Prairie Island Nuclear Generating Plant
1717 Wakonade Drive East
Welch, MN 55089

L-PI-14-069
10 CFR 72.42

Prairie Island Independent Spent Fuel Storage Installation
Docket No. 72-10
Materials License No. SNM-2506

Supplement to License Renewal Application – Response to Second Request for
Additional Information (TAC No. L24592)

Figure A2.10-1
Two Meter Gamma Dose Rates

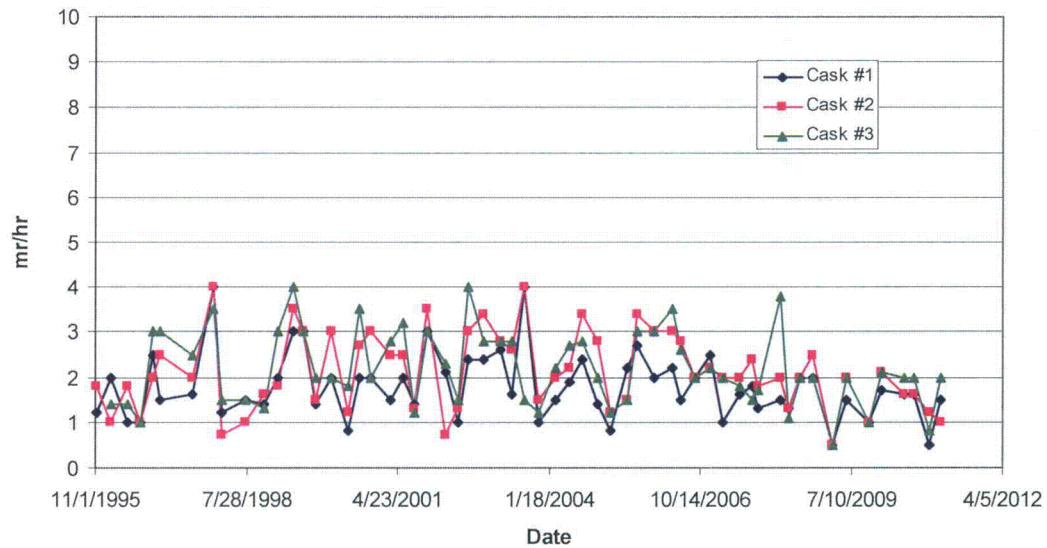
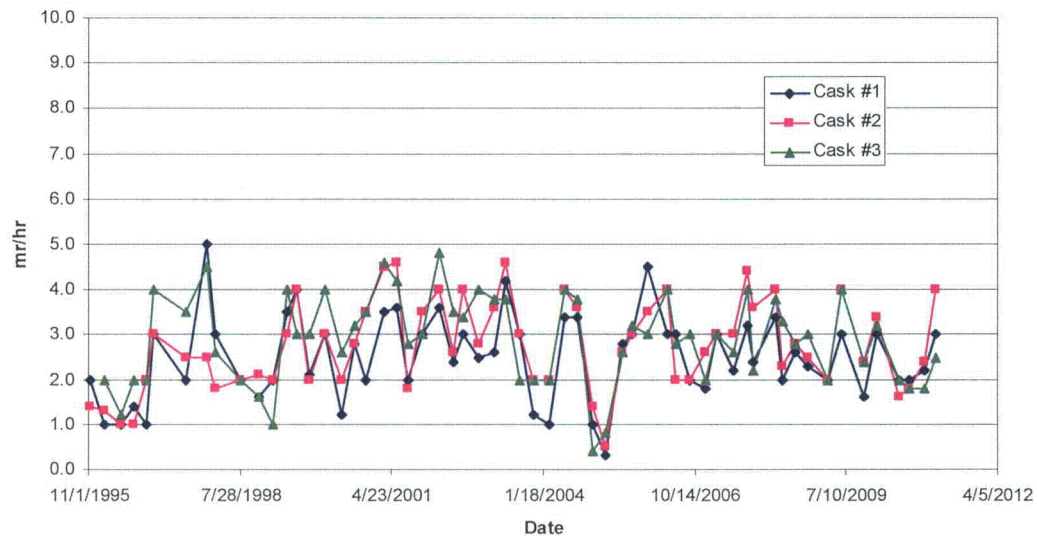
The staff believes that due to either inconsistencies in the measurement technique, equipment, locations, variations in background, or a combination of all of these factors, the data (LRA Figure A.2.10 -1.2, and RAI A-1 response) presented is insufficient to detect degradation of the

NSPM Response:

Trending neutron dose rate readings from the same location on each cask is consistent with the aging management principle of sampling representative locations and casks rather than 100% of surfaces on all casks, as further discussed in NUREG-1927, AMP Element 4 and Appendix E. While no attempt is made to ensure that the fuel loadings within a cask are truly symmetrical, it is reasonable to assume that the actual loads result in a fairly uniform radial source term. SAR Figure A7.2-2 shows the axial gamma and neutron power profiles, i.e., the axial source term, used in the safety analysis. This figure shows that the highest axial source terms are approximately one meter from the bottom of the cask. Since the most likely aging effect of the shielding material is due to radiation damage, it is reasonable to expect that the most likely location for degradation to occur is approximately one meter from the ground, and that any such degradation would be uniform radially. Therefore, trending neutron radiation readings from every cask, at an elevation of one meter, and at a single radial location two meters from the outer shell provides an adequate sample size to ensure timely detection of aging effects that could lead to a loss of intended function.
